# SERVICE LETTER

No. 373

Piper Aircraft Corporation

**SUBJECT:** Installation of Oil Shields on Airborne Mechanisms Dry Vacuum Pumps, Models 113A1 and 113A5

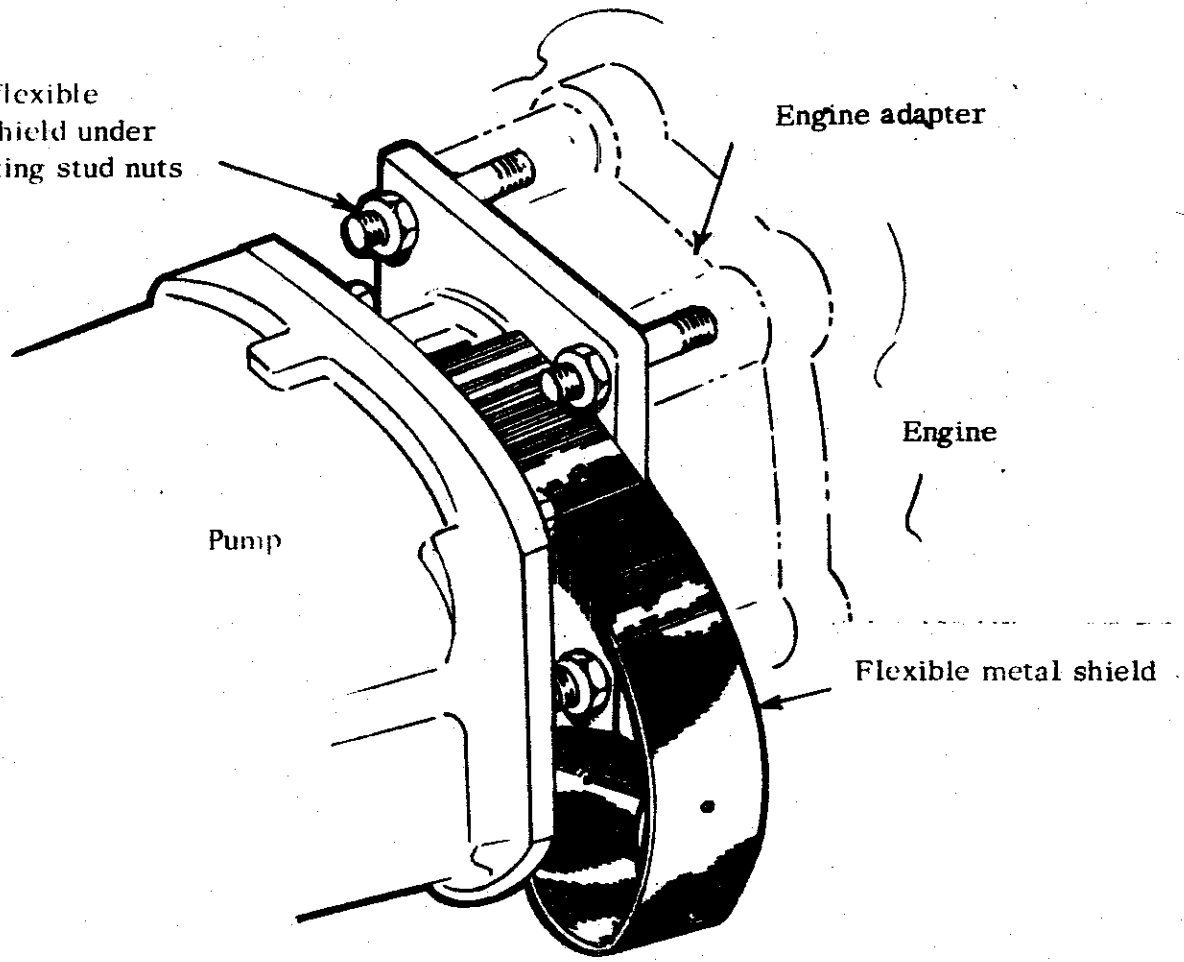
It has been determined that occasionally oil or cleaning solvents have entered the ventholes in the face of the mounting flange of the 113A1 and 113A5 Airborne Mechanisms dry vacuum pump.

A flexible metal shield, part number 756 143, which is easily installed by threading under the pump mounting bolts, has been designed to protect these openings. Removing the pump is not necessary and the shield does not require fastening as the spring tension of the shield will hold it in its proper position, once installed. Installation of this shield is recommended on the subject aircraft equipped with Airborne Mechanisms Dry Vacuum Pumps. See sketch on the reverse side of this letter.

During installation or removal of the pump, the shield should be removed to prevent damage to the shield.

Install flexible  
metal shield under  
4 mounting stud nuts

Vent holes to be  
covered by flexible  
metal shield
